UNITED STATES PATENT AND TRADEMARK OFFICE

APPLICATION NO.	FILING DATE	FIRST NAMED INVENTOR	ATTORNEY DOCKET NO.	CONFIRMATION NO.
09/981,957	10/16/2001	Brian James Misek	10010215-1	7262

Office Action Summary

DETAILED ACTION

To help clarify Examiner's position, relevant parts of Fig. 4 of the prior art is included below.

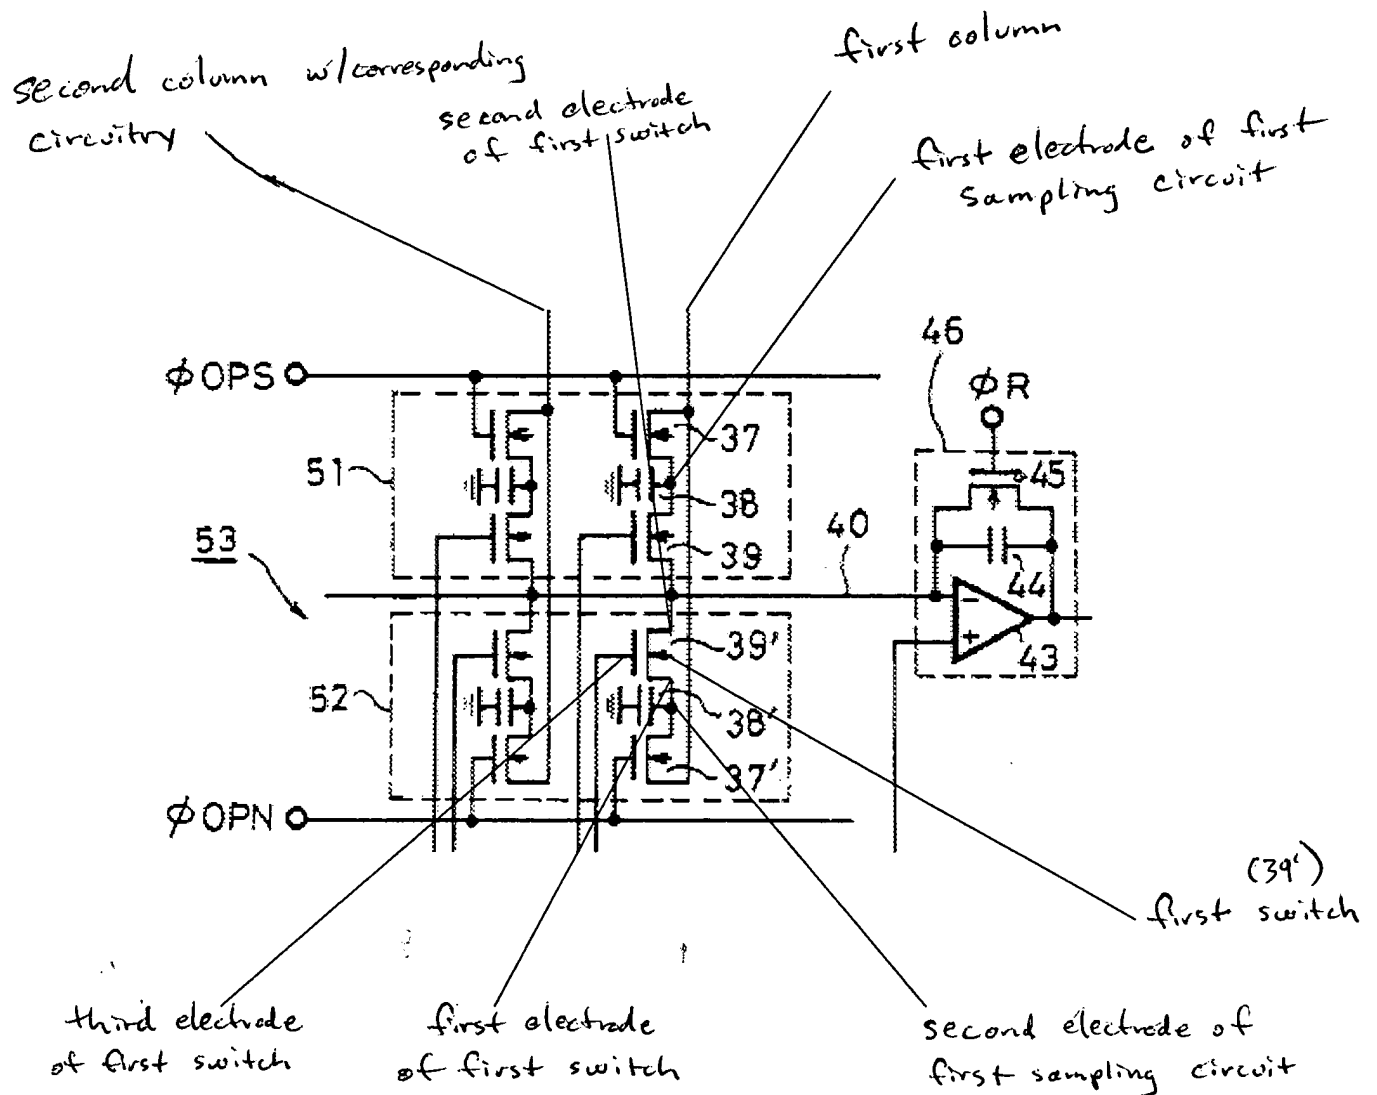
Regarding claims 3, 5, 11, 14 and 22-30, Yonemoto et al. disclose (see Fig. 4) a system comprising: an array of photocells (32) that are arranged in rows and columns, and a sequential readout circuit for sequentially reading out the value of the photocells

one photocell at a time, wherein the readout circuit includes: a first sampling circuit (38, 38') that includes a first electrode (electrode of 38 near 37) for coupling to a first column and a second electrode (electrode of 38' near 39'); a first switch (39') that includes a first electrode coupled to the second electrode of the first sampling circuit, a second electrode, and a third electrode (gate) for receiving a first sample control signal; wherein the first switch selectively couples the first electrode of the first switch to the second electrode of the first switch when the first sample control signal is asserted; wherein the first sampling circuit samples a light signal (from 38) and a reset signal (from 38') from each photocell in the first column; a second sampling circuit and second switch (see elements in adjacent column, not labeled) as claimed; and an amplifier (43) that includes a negative input terminal coupled to the second electrode of the first and second switches; wherein the amplifier includes an output terminal for generating a signal that corresponds to the amount of light received by a particular photocell in the array. Yonemoto et al. also disclose (see Fig. 4) determining a difference (47) between the light signal and the reset signal, and an integration capacitor (44) as claimed. Yonemoto et al. further disclose (see Fig. 4) the sampling circuit includes a sampling capacitor (38 or 38').

Applicant asserts that the prior art does not disclose a first sampling circuit having electrodes and that samples both a light signal and a reset signal. Examiner

disagrees. Examiner has clarified the rejection and as set forth above, as understood, the prior art does disclose such features. Thus, this rejection is proper.
